City of West Sacramento
Flood Engineering Services
Alternatives Analysis Report

Subject: City of West Sacramento – Flood Program Services – Final Alternatives Analysis Report

Enclosed is the Alternatives Analysis Report that was prepared by Wood Rodgers, Inc. for the subject project. Comments from the City of West Sacramento and the Independent Panel of Experts on the draft version of this report (dated March 2016) have been incorporated as appropriate. A comment and response register is included as Attachment D of the enclosed Alternatives Analysis Report.

**WEST SACRAMENTO
 FLOOD PROGRAM**
 YOLO BYPASS EAST LEVEE
 REACH 1 - STA 0+00 TO 24+52
 ALTERNATIVE 1 CROSS SECTION

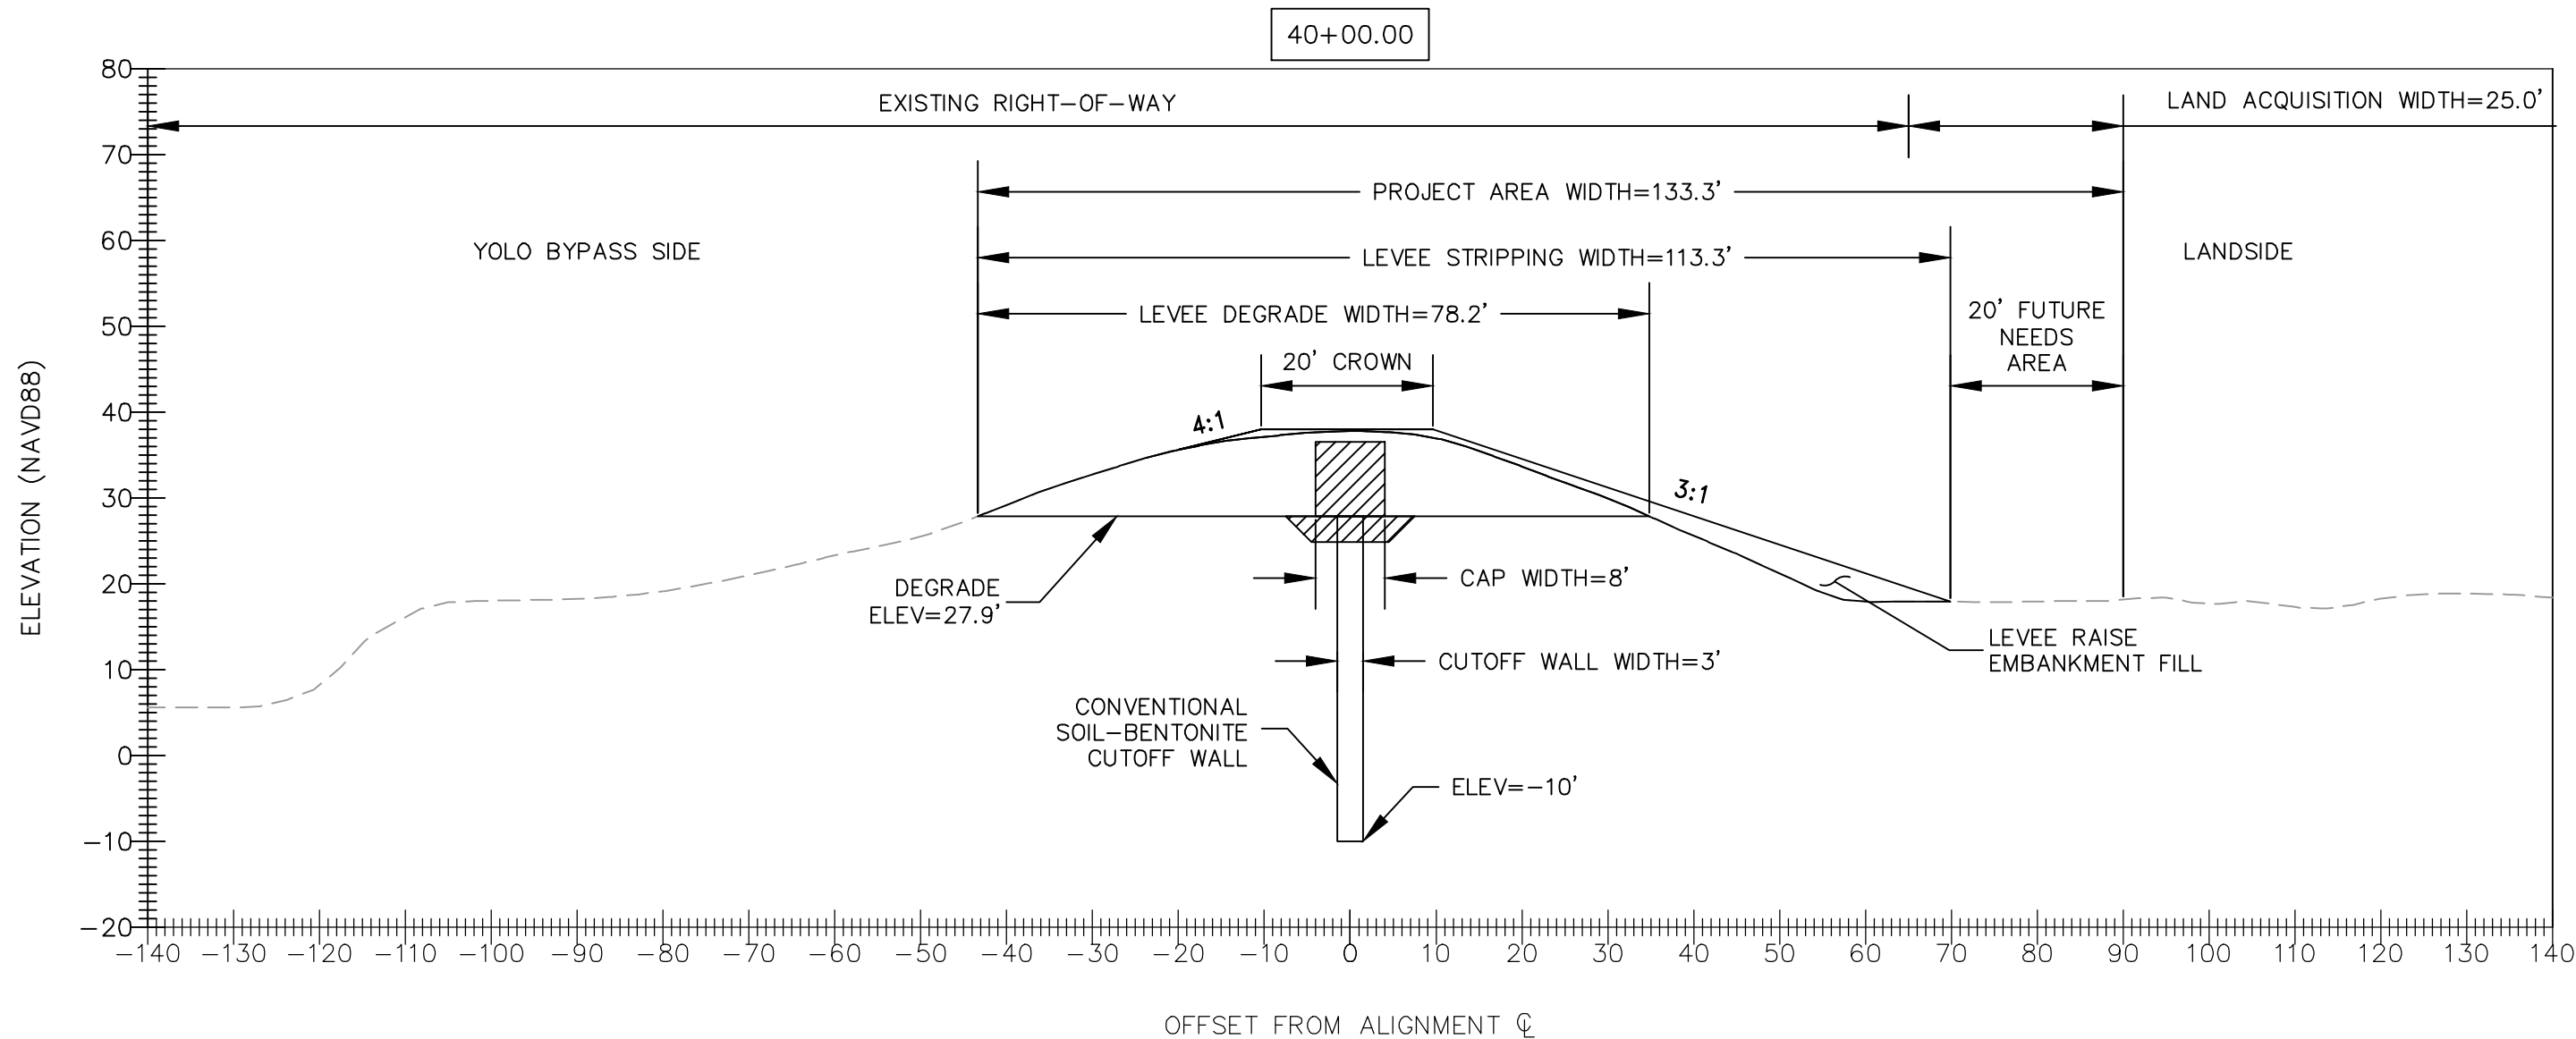
| ADMIN USE ONLY | REVIEWER | | | | RESPONDENT | | | | REVIEWER | | | RESPONDENT | | | |
|---|---------------------------|--|--|---|--------------------------------|---------------------------------|---|--------|------------|-----|---------------|-----------------|------------------|---|---------------------|
| 129 | IPE | Levee, Station 15+00, Figure 1 of 10 | 4/19/16 | What about a schematic water surface? | Jesse Patchett Wood Rodgers | 4/21/16 | The schematic water surface will not be added as discussed in the response to comment 119. | | X | | | Y | 5/7/2016 | | n/a |
